August 10, 1984  
84056.019

Subject: Cable Tray Support and Electrical Review Questions  
Comanche Peak Steam Electric Station  
Independent Assessment Program - Phase 4  
Texas Utilities Generating Company  
Job No. 84056

5. Special Type per CMC 85720 (Revisions 0 - 4)  
Hanger Number 13080

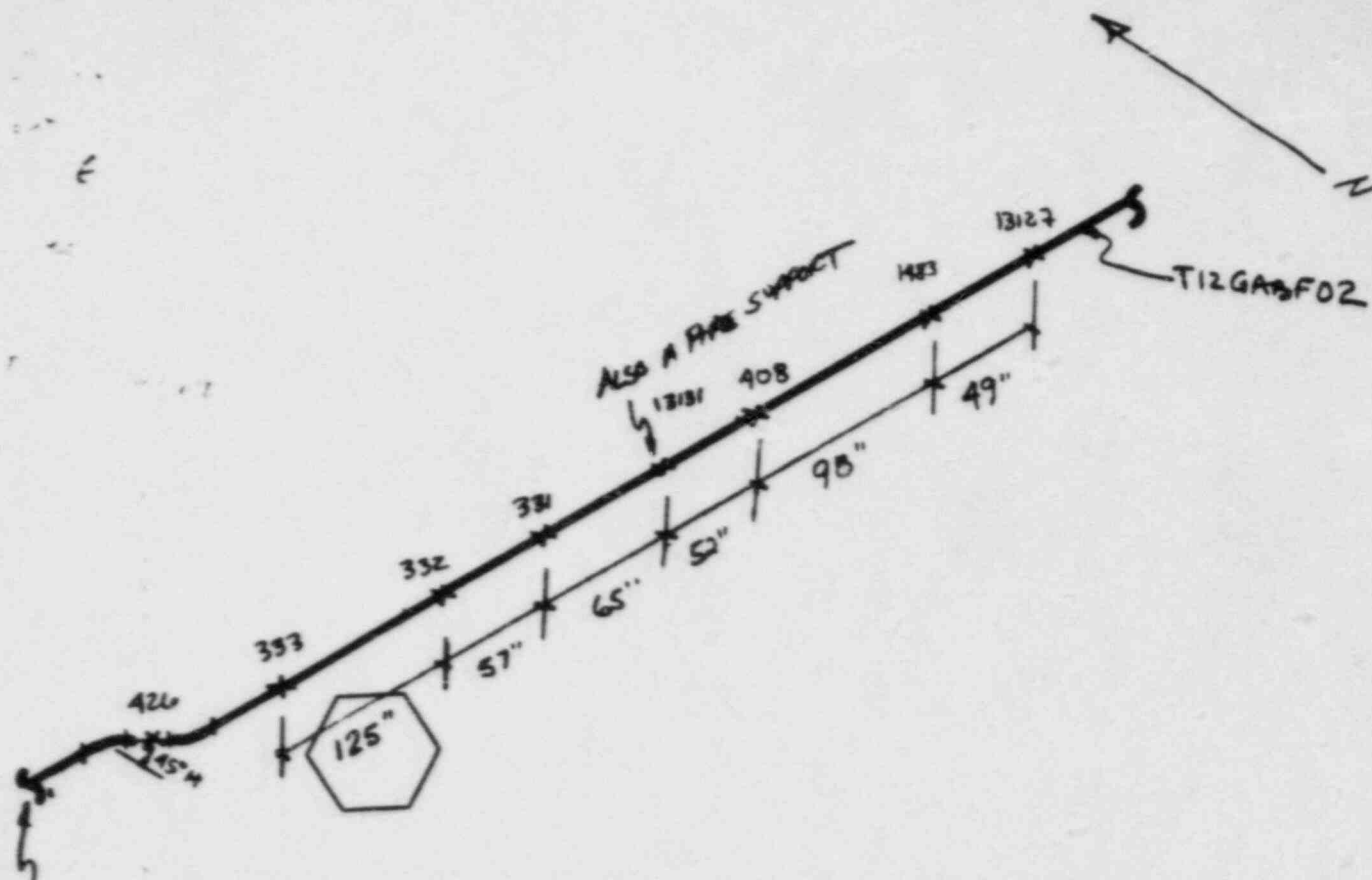
Cable tray support 13080 was originally designed to replace support 594. A review of the CVCs for revisions 0 - 4 of CMC 85720 state that no new or revised design calculations were required to verify the adequacy of the support. A calculation sheet with design calculations is attached to revision 3 of the CVC but the calculations are unsigned and marked "For Reference Only." During Cygna's review of the available documentation on the support's design, the following points were noted:

- (a) The tray support is located at a tee intersection of trays. It employs heavy clamps and is skewed with respect to the transverse axis of the cable tray. Due to its location, orientation and the use of the heavy duty clamps, the support is required to be designed for vertical, transverse and longitudinal loads. The longitudinal loads were not considered in any calculation, including those marked "For Reference Only."
- (b) The base plate was designed for a specific orientation and location of the 6" x 6" tube steel column. Subsequently, several modifications to the support resulted in a final orientation and location of the tube steel attachment. No calculations were performed to analyze the effects of these attachment alterations on the base plate and anchor bolts. Cygna believes that the final orientation as shown

on sheet 2 of CMC 85720, Rev. 4 differs greatly from the original orientation. Therefore, the present configuration cannot be qualified by similarity to the originally design condition.

Please provide Cygna with justification that the effects discussed above will not prevent the support from resisting any applied loads.

CABLE TRAYS- AS BUILT ISOMETRICS  
AUXILIARY BLDG. EL 790'-6"  
REF. DWG. F&E 00174

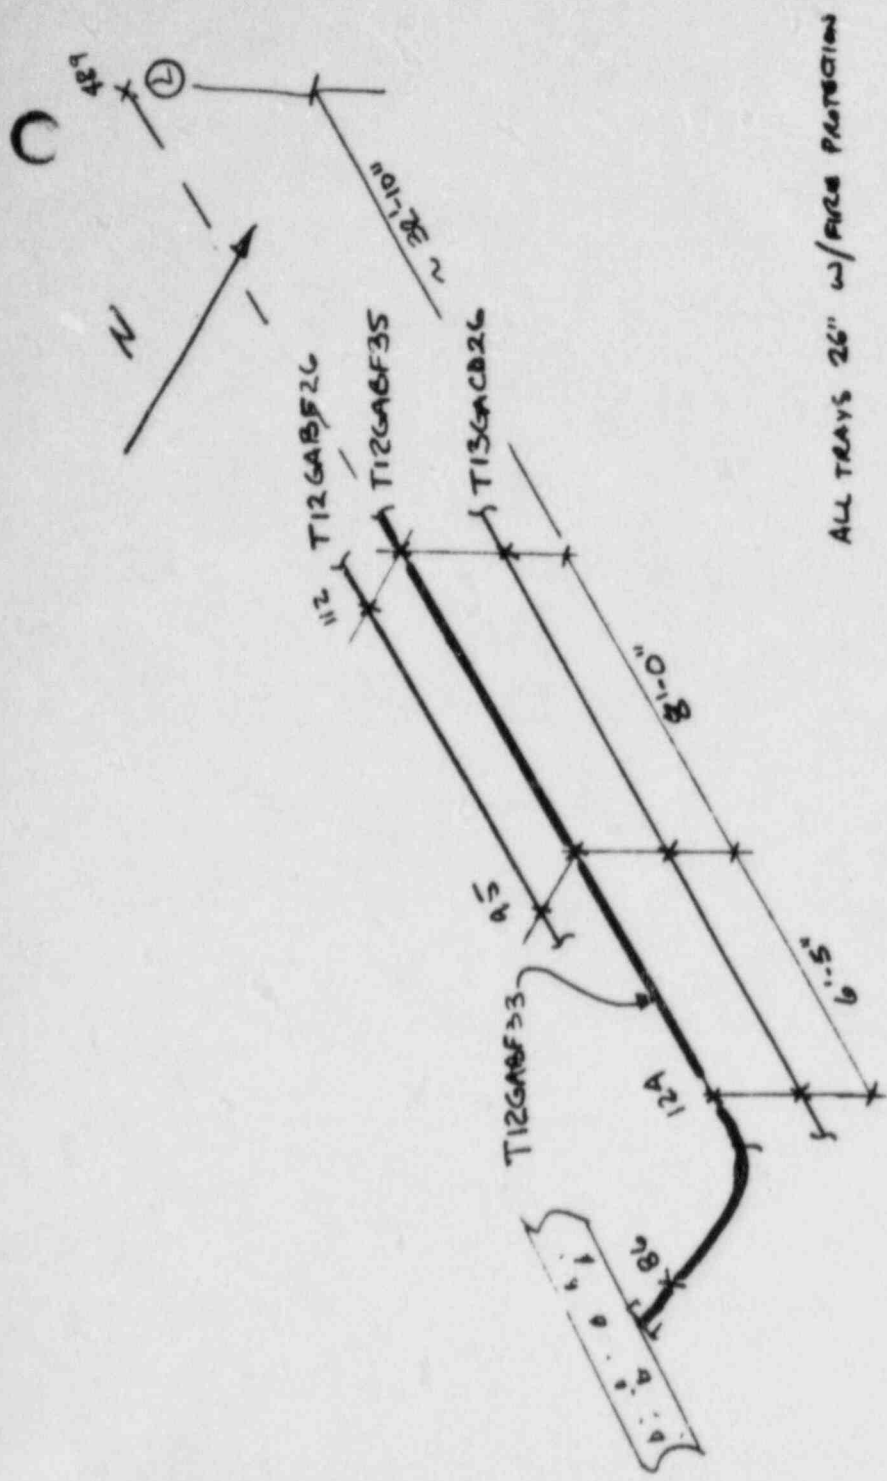
Ref. Dwg. No.	Cygna Iso. Sht.	Tray Seg. No.	Span	Supports No. Starting	Ending	Fire Protection
FSE-00174	1	T120ABC03	11'-0"	299	479	Yes
FSE-00174	2	T12GABF04	10'-5"	333	332	Yes
FSE-00176	4	T110SAA15	8'-4"	592	593	No
FSE-00176	4	T110SAA13	12'-0"	655	656	No
FSE-00176	5	T120SBC36	8'-8"	764	765	No
FSE-00176	5	T120SBC25	8'-4"	724	726	Yes
FSE-00176	5	T120SBC25	8'-2"	722	723	Yes
FSE-00176	6	T120SBC29	9'-3"	620	587	No
FSE-00185	7	T120ABC10	8'-9"	2986	2998	Yes
FSE-00185	7	T120ABC17	10'-0"	2953	2990	Yes
FSE-00185	8	T110AAA08	8'-10"	2992	2993	Yes
FSE-00185	8	T110AAA10	9'-4"	3134	2861	Yes

Ref. Dwg. No.	Cygn Iso. Sht.	Tray Seg. No.	Span	Supports No. Starting	Ending	Fire Protection	Comments
FSE-00174	1	T120ABC04	11'-10"	---	---	Yes	No longit. support on run between riser at CTH 367 and horiz. elbow at CTH 479.
FSE-00174	2	T12GABF01 to T12CABF04	40'	---	---	Yes	No longitudinal supports in this entire run from col. lines F-A through K-A.
FSE-00174	3	T12GABF33	48'	489	---	Yes	Span exceeds 40' from a longit. support to the elbow at CTH 124.
FSE-00176	4	T110SAA18	5'	---	---	No	No longitudinal support between elbow at CTH 589 and end of run at CTH 720.
FSE-00176	4	T110SAA11	60'-5"	3134	5807	No	Longitudinal span exceeds 40'-0"
FSE-00176	5	T120SBC25	57'-5"	2920	13080	Yes	Longitudinal span exceeds 40'-0"
FSE-00176	6	T120SBC29	60'-2"	586	587	No	Longitudinal span exceeds 40'-0"
FSE-00185	8	T110AAA08	10'-4"	---	---	Yes	No longitudinal supports on run between elbow at CTH 2923 and wall penetration at col. line F-A

CABLE TRANS - AS BUILT ISOMETRICS  
 AUXILIARY BLDG., EL 790'-6"  
 REF. DWG, FSE-00185

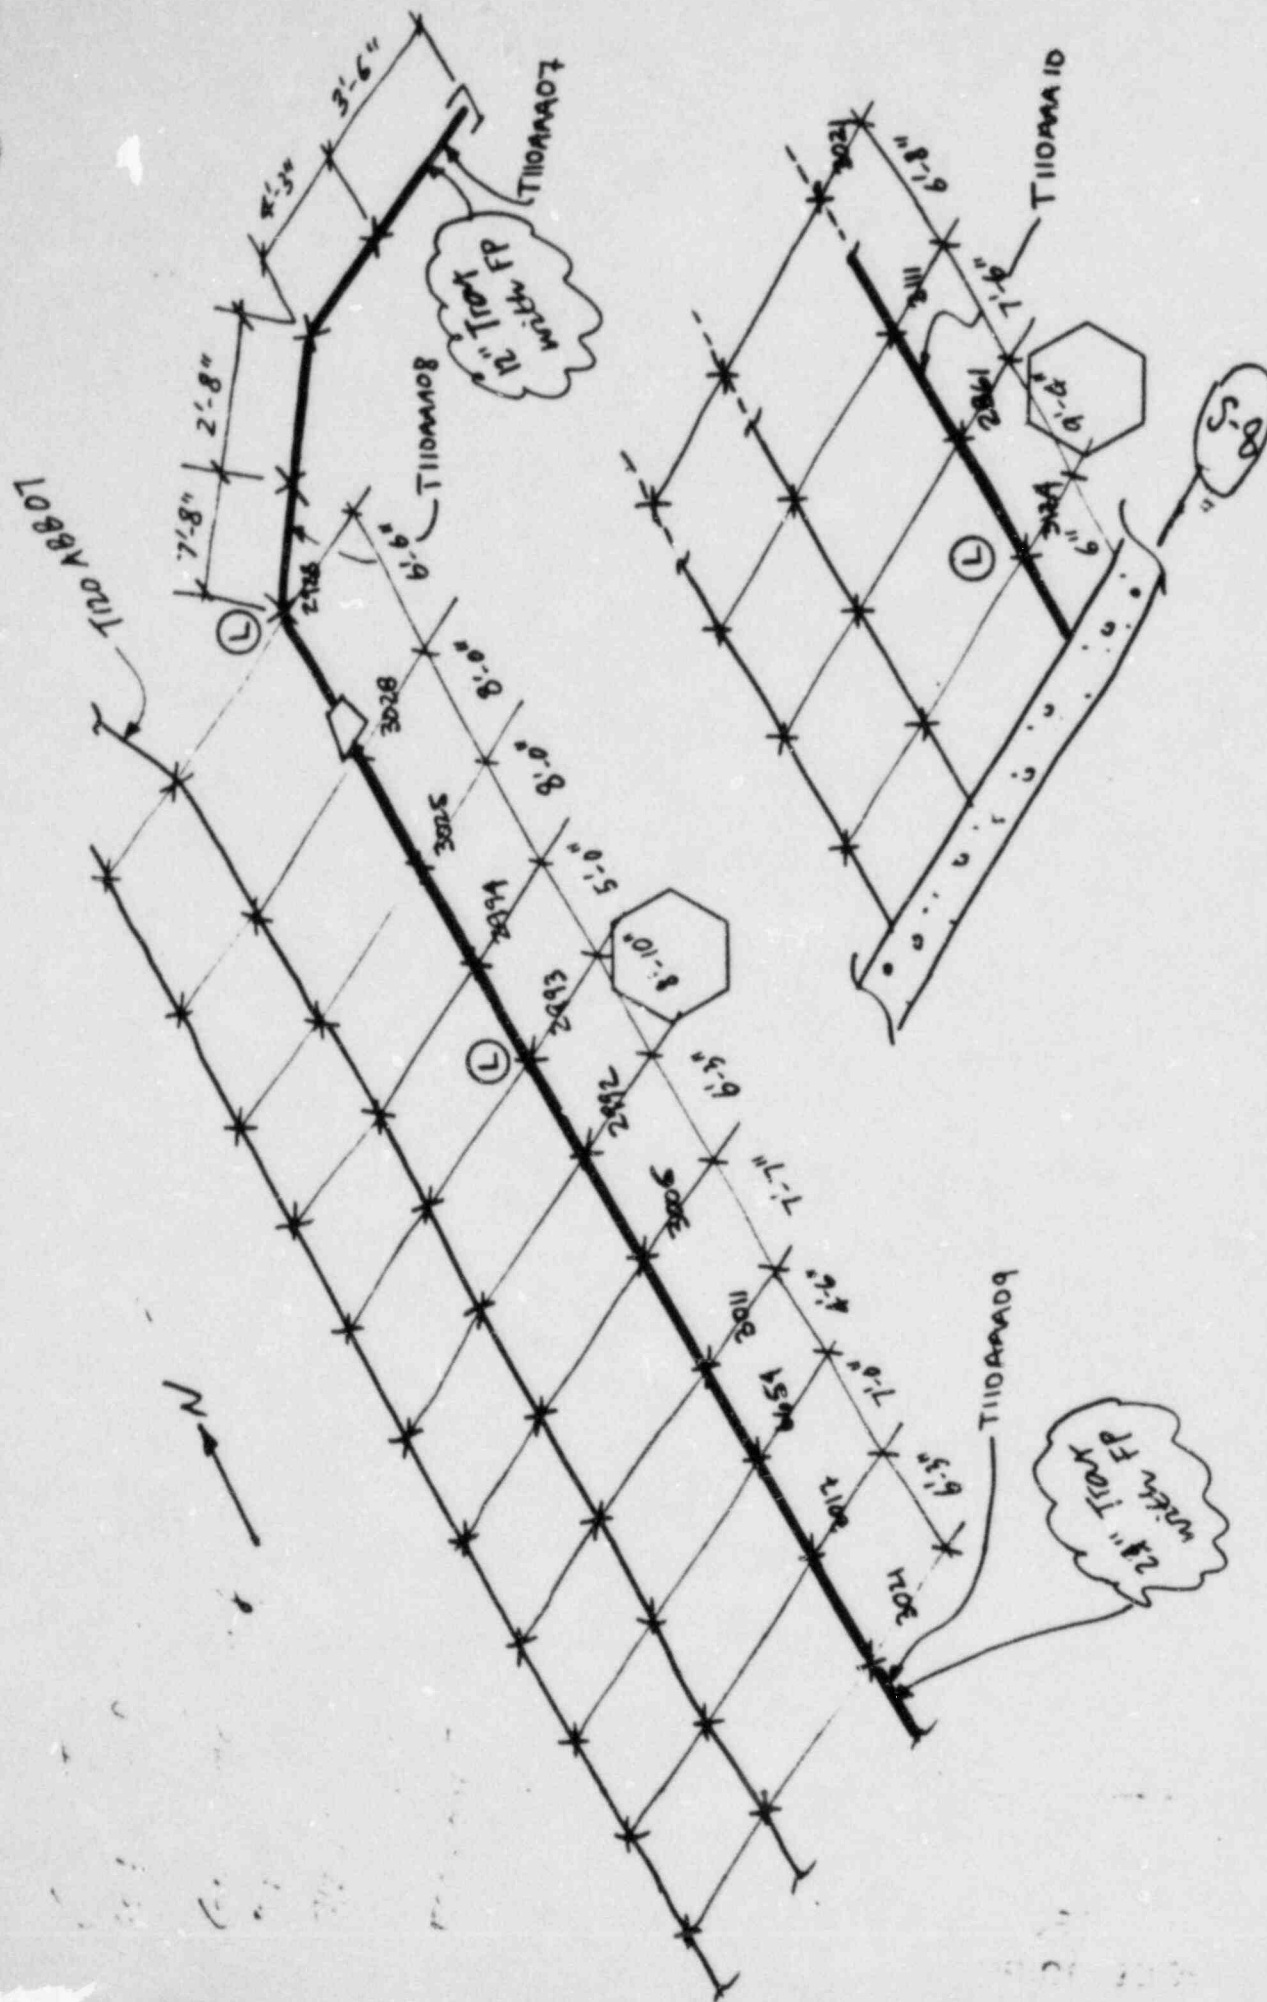
FSE-00185	8	T110AAA10	63'-11"	2993	3134	Yes	Longit. span exceeds 40'-0"
